NELSON ESTATES SUBDIVISION

The purpose of this application is to create a 12-lot subdivision from a metes and bounds parcel.

APPLICATION NUMBER 3 DATE February 1, 2007

DETAIL SITE PLAN

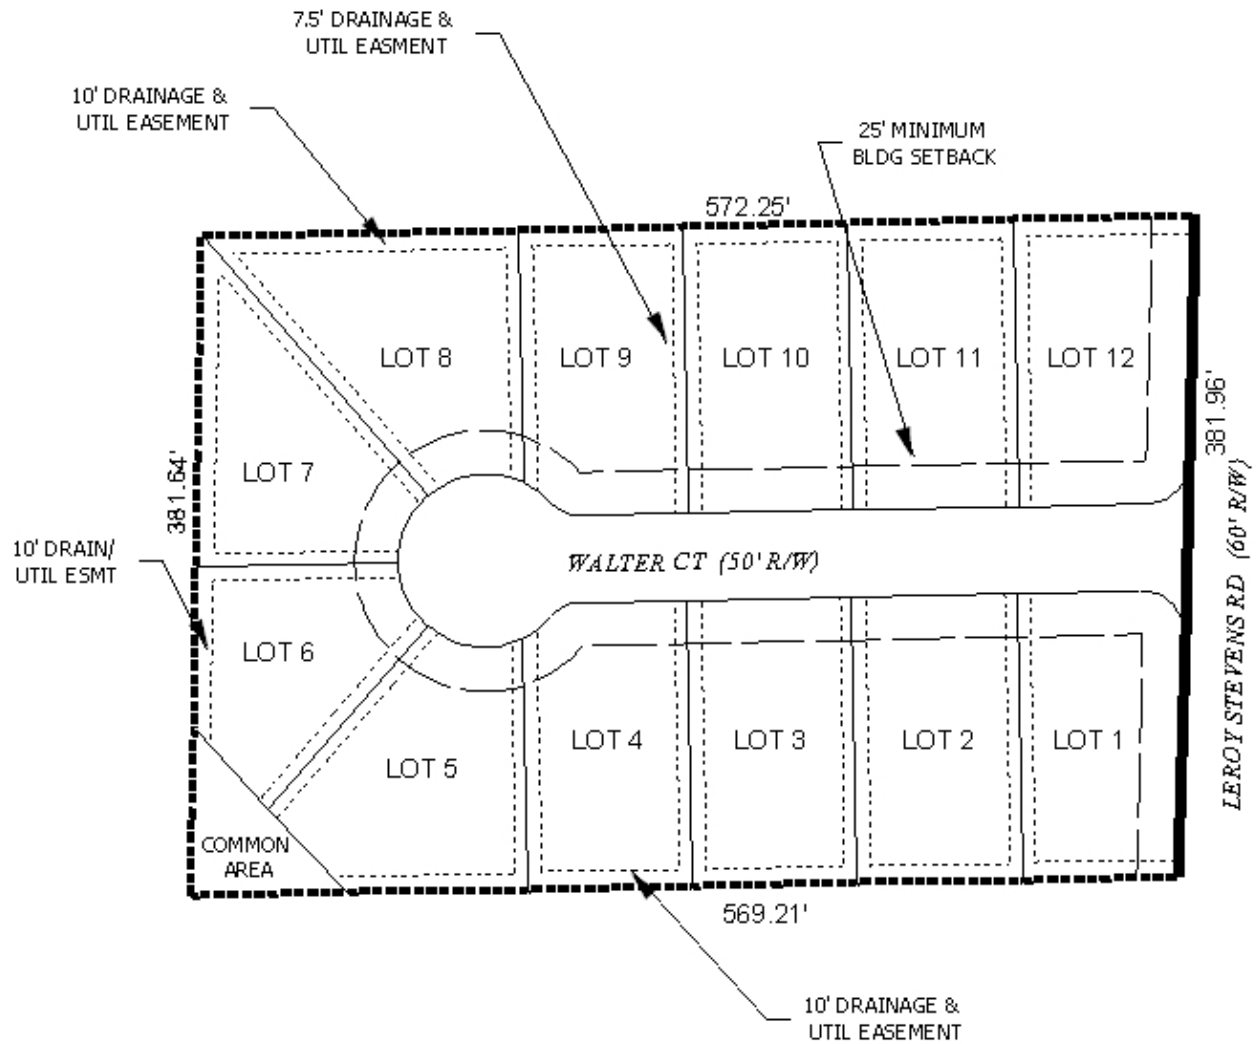
As a means of access management, the placement of a note on the final plat stating that Lots 1 and 12 are denied direct access to Leroy Stevens Road, should be required. Additionally, any new road for the site is to be dedicated and constructed to meet County Engineering Standards. Additionally, Lots 1 and 12 being corner lots, the dedication of a sufficient radius at Leroy Stevens Road and the new street as determined by County Engineering should be required.

Any common area, including detention basins, road islands and medians, should be labeled as commons areas. A note should be placed on the Final Plat stating that the maintenance of all common areas is the responsibility of the property owners.

This site is located in the County, thus a note should be placed on the final plat stating that any lots which are developed commercially and adjoin residentially developed property must provide a buffer, in compliance with Section V.A.7. of the Subdivision Regulations.

While the site is located in the county, compliance with the City of Mobile stormwater and flood control ordinances will be required. A letter from a licensed engineer certifying compliance with the City's stormwater and flood control ordinances should be submitted to the Planning Section of Urban Development prior to the signing of the final plat, if approved.

The plat meets the minimum requirements of the Subdivision Regulations and is recommended for Tentative Approval subject to the following conditions: 1) dedication and construction of new roads to meet County Engineering Standards; 2) the placement of a note on the final plat stating that Lots 1 and 12 are denied direct access to Leroy Stevens Road; 3) the dedication of a sufficient radius at Leroy Stevens Road and the new street as determined by County Engineering; 4) placement of a note on the Final Plat stating that the maintenance of all common areas are the responsibility of the property owners; 5) the placement of a note on the final plat stating that any property that is developed commercially and adjoins residentially developed property shall provide a buffer, in compliance with Section V.A.7. of the Subdivision Regulations; and 6)

provision of a certification letter from a licensed engineer to the Planning Section of Urban Development and the Mobile County Engineering Department, certifying that the stormwater detention and drainage facilities comply with the City of Mobile stormwater and flood control ordinances prior to the signing and recording of the final plat.
